Docket Item # 11
BAR CASE # 2006-0224

BAR Meeting
October 18, 2006

ISSUE: Addition
APPLICANT: Gregory Lucy by Stephanie Dimond
LOCATION: 517 North Columbus Street
ZONE: RM/Residential

Figure 1 - Proposed east (rear) elevation

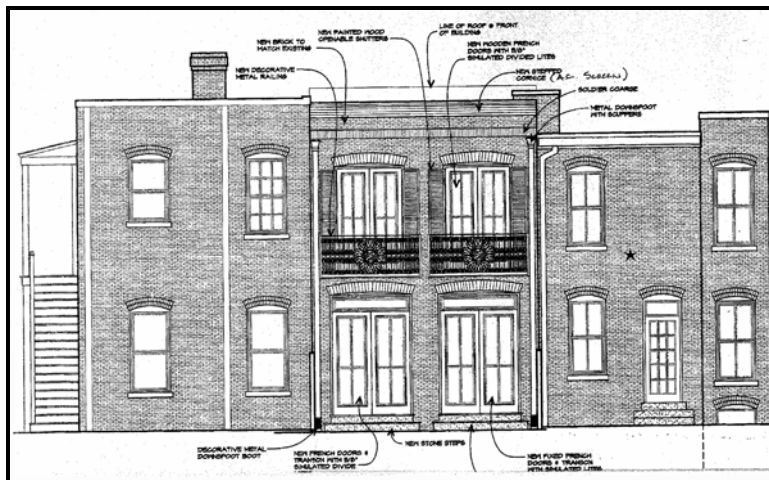
The applicant is requesting approval of a certificate of appropriateness for a new two story rear addition. The addition will extend from lot line to lot line, filling in the dog leg, and extend beyond the present rear wall by an additional 10' 11". The addition will have a flat roof that will continue the slope of the main roof. The walls will be clad in brick. The rear (east) elevation will have two paired French doors on each story. The doors will be wood with simulated divided lights in a four-light configuration. The muntins will be 5/8 wide. There will be a transom above the first story doors and stone steps to the rear yard. The second story doors will have painted wood louvered shutters and decorative metal railings. The shutters will be operable and, according to the architect, will be bi-fold to fully fill the openings. The railing design is based on an historic railing elsewhere in the historic district. There will be brick jack arches over the door openings. There will be a brick soldier course above the second story and a stepped brick cornice. The roof will drain to the rear through scuppers into metal downspouts at either side of the rear elevation. The downspouts will be rectangular and of aluminum. The south side elevation will not extend beyond the house at 515 North Columbus Street. The north side elevation will extend beyond 517 North Columbus, the pair with the subject house, by 10' 11". This elevation will be blind and will be clad in brick.

According to the architect, the existing rooftop HVAC unit will be sufficient to service the new construction and will remain in place. The rear elevation will be visible from the public alley at the rear but is not likely to be visible from the adjacent streets. The property has a 6' rear fence that will obscure much of the first story.

In the opinion of Staff, the proposed addition is appropriate for the house and surrounding district and complies with the *Design Guidelines* for additions. The addition is relatively modest in size and utilizes materials and architectural forms that are compatible with the early 20th century rowhouse and its neighbors. Staff finds the railing design, borrowed from a high style mid-19th century building, to be overly ornate for this simple structure. However, given its location in the rear where it will be visible only from the adjacent alley, Staff has no objection.
